UNITED STATES PATENT AND TRADEMARK OFFICE

APPLICATION NO.	FILING DATE	FIRST NAMED INVENTOR	ATTORNEY DOCKET NO.	CONFIRMATION NO.
10/583,307	03/06/2007	Kiyoshi Sadakata	KAM 22.600 (100799-00133)	5093
26304 7590 05/28/2009 KATTEN MUCHIN ROSENMAN LLP 575 MADISON AVENUE NEW YORK, NY 10022-2585			EXAMINER FREEDMAN, LAURA	
			ART UNIT 3616	PAPER NUMBER
			MAIL DATE 05/28/2009	DELIVERY MODE PAPER

Office Action Summary	Application No. 10/583,307	Applicant(s) SADAKATA, KIYOSHI	
	Examiner Laura Freedman	Art Unit 3616

DETAILED ACTION

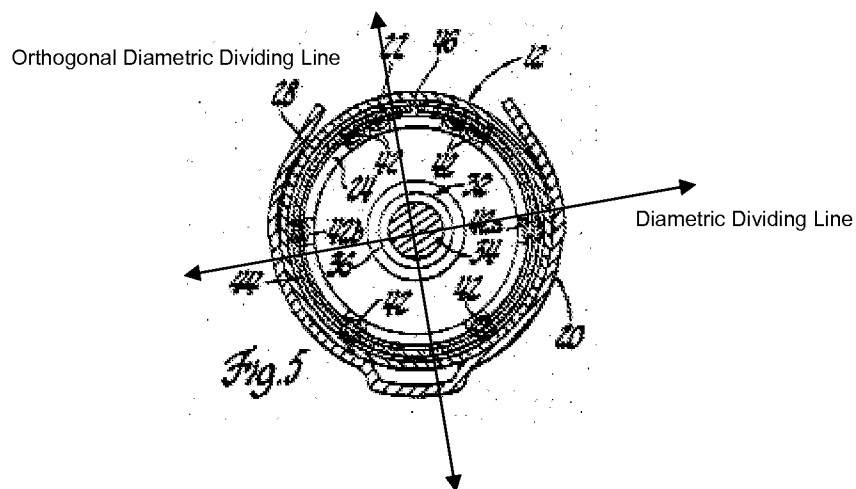
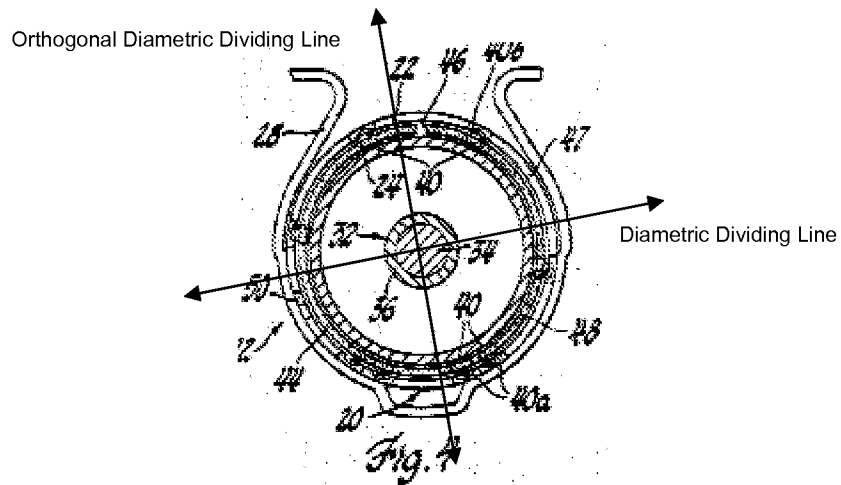
- In the case where it is assumed that the overlap portion is divided into two in a diametric direction (for example, as indicated by diametric dividing line in marked-up figures below), each of the engaging portions exists in a state biased towards a position away from the divided section (for example, including #40, 42, 40a, 40b, 42a, 42b located away from diametric dividing line)

- The engaging portions exist in four places in relation to the circumferential direction (for example, including top, bottom, left side, and right side in figures 4, 5)

- An interval in relation to the circumferential direction between engaging portions that exist astride an imaginary line orthogonal to the direction of division (as indicated by orthogonal diametric dividing line in marked-up figures below) is made smaller than an interval in relation to the circumferential direction between engaging portions that exist astride an imaginary line in the direction of division (for example, an interval between #40, 42 located on the upper portion of #22, 24 and to the left of the orthogonal diametric dividing line in figures 4, 5 and the orthogonal diametric dividing line, is made smaller than an interval between #40, 42 located on the left side of #22, 24 and above diametric dividing line in figures 4, 5 and the diametric dividing line, as can be seen in marked-up drawings below)

- Each of the engaging portions is arranged unevenly in relation to the circumferential direction (for example, can be seen in figures 3-5, 7)
- The arrangements of the respective engaging portions are biased in the vertical direction in an installed state (for example, more engaging portions are located in the upper and lower portions, in comparison to the left and right sides, as can be seen in figures 4, 5)

- Of each of the engaging portions, the number of engaging portions upon which the bending force acts at the time of a collision (for example, including those engaging portions located

closest to the orthogonal diametric dividing line) is made to be greater than the number of the other engaging portions (including bottom of column 3-top of column 4)

Examiner notes that lines drawn in the marked-up figures below may not intersect exactly at the center point of the steering column components, and may not be precisely orthogonal to each other, but have been drawn to the best of her ability, and are merely exemplary in nature.
